STAFF RECOMMENDATION 1519 McKennie Avenue November 18, 2015

Application: Demolition; New construction - infill
District: Eastwood Neighborhood Conservation Zoning Overlay
Council District: 06
Map and Parcel Number: 08302023700
Applicant: Scott Nicodemus, Developer
Project Lead: Sean Alexander, sean.alexander@nashville.gov

Description of Project: The applicant proposes to demolish a non-contributing house and to construct a new one and one half-story duplex.

1 | SOUTH ELEVATION
A-2.0 | 1/8" = 1' 0"

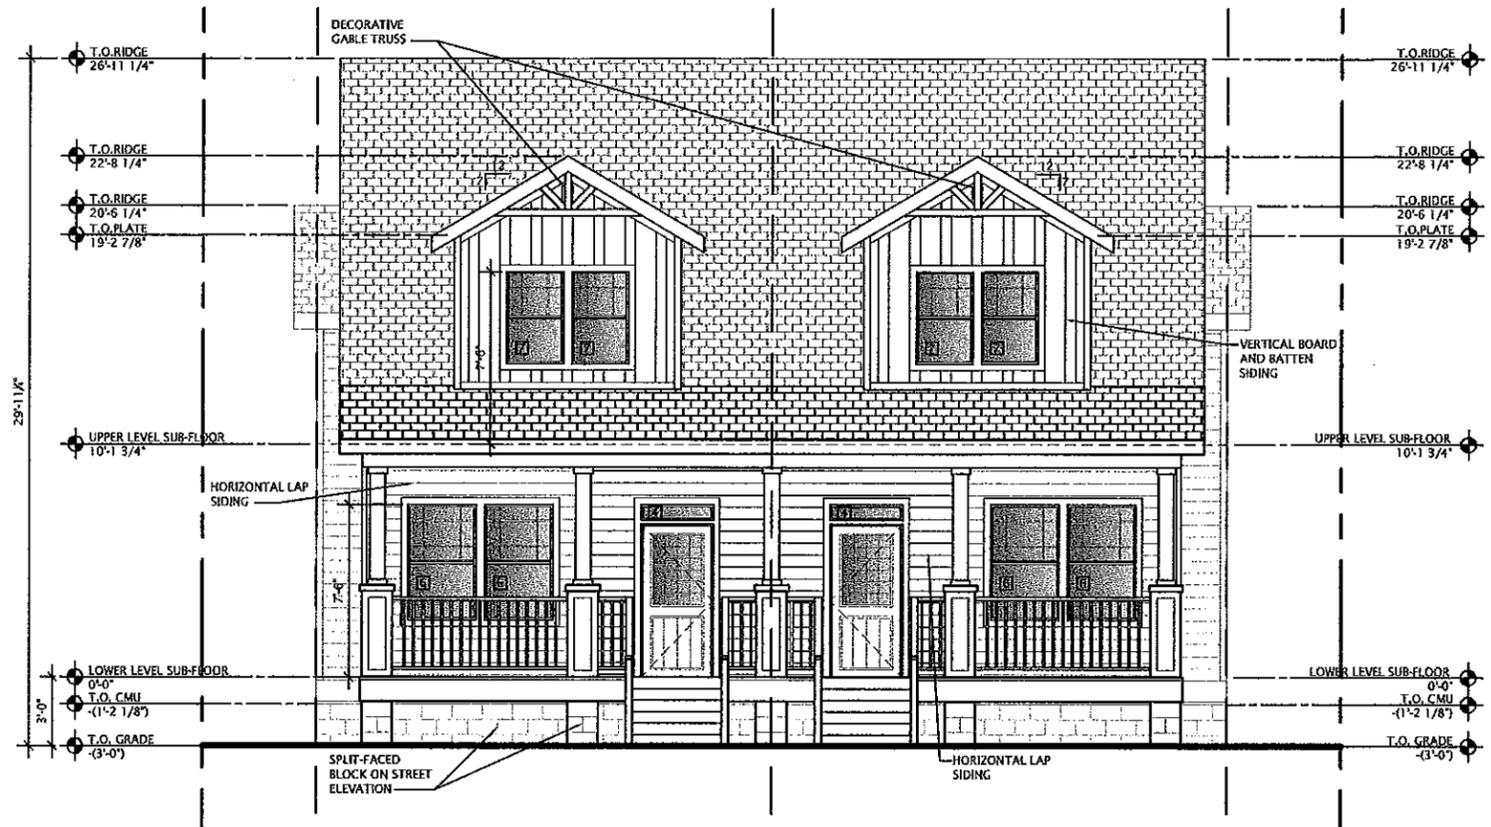
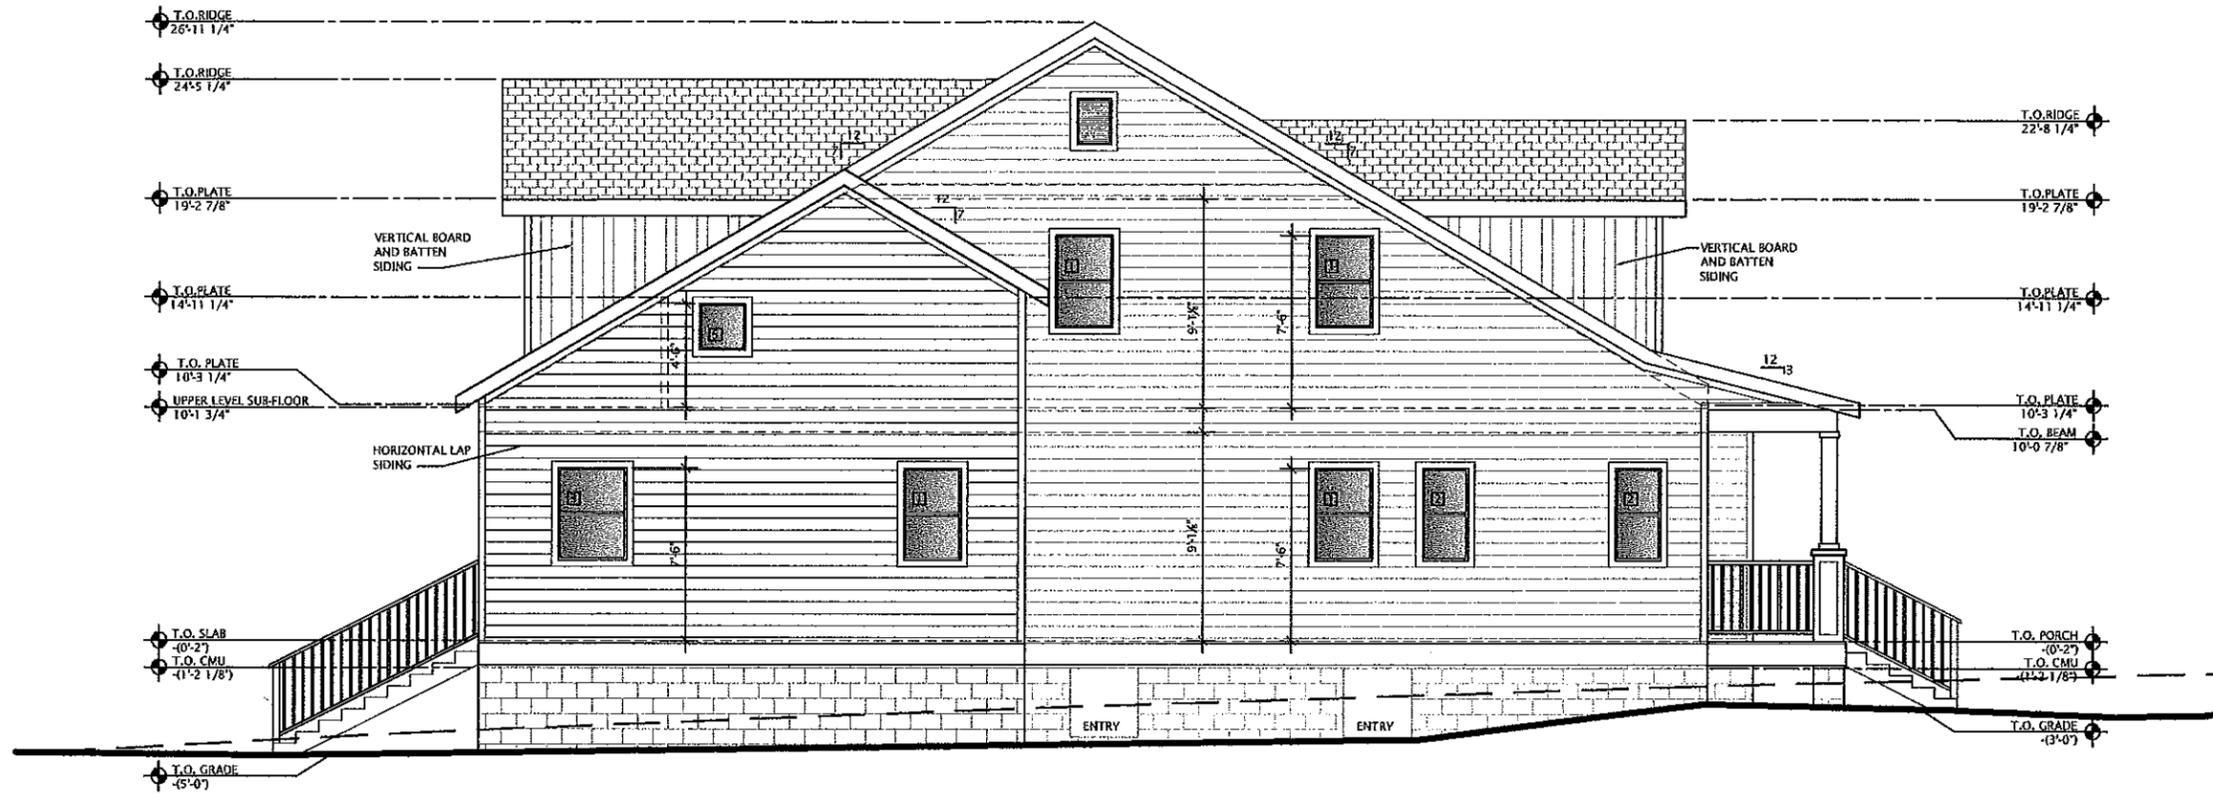
Height & Scale: The new building will be a one and one-half story duplex with a form similar to that of a side-gabled Craftsman house. The roof peak will be twenty-seven feet (27') above the finished floor level. With a twenty-four inch (24") tall foundation and a twelve inch (12") water table, the floor level would be three feet (3') above grade. These heights are compatible with nearby historic houses, which range from twenty-two feet (22') to thirty feet (30') tall from grade. During construction, Staff will verify that this floor height is compatible with surrounding historic houses.

The front façade of the building will be thirty-six feet (36') wide, with projecting bays on both sides expanding the total width to forty feet (40'). The majority of historic houses nearby range between thirty feet (30') and thirty-nine feet (39') wide; however, the context on this block of McKennie is more recent than the rest of the neighborhood, with wider lots and wider buildings than areas with stronger historic character.

Roof form: The primary roof of the building will be a side-oriented gable with a pitch of 7:12, with smaller gables projecting to the sides near the rear of the building. A pair of gabled dormers will be on the front slope of the roof, sitting four feet (4') below the primary ridge and two feet (2') back from the leading edge of the building as is typical of

Proportion and Rhythm of Openings: The windows on the proposed new building are all generally twice as tall as they are wide, thereby meeting the historic proportions of openings. There are no large expanses of wall space without a window or door opening. Staff finds the project's proportion and rhythm of openings to meet Section II.B.1.g.
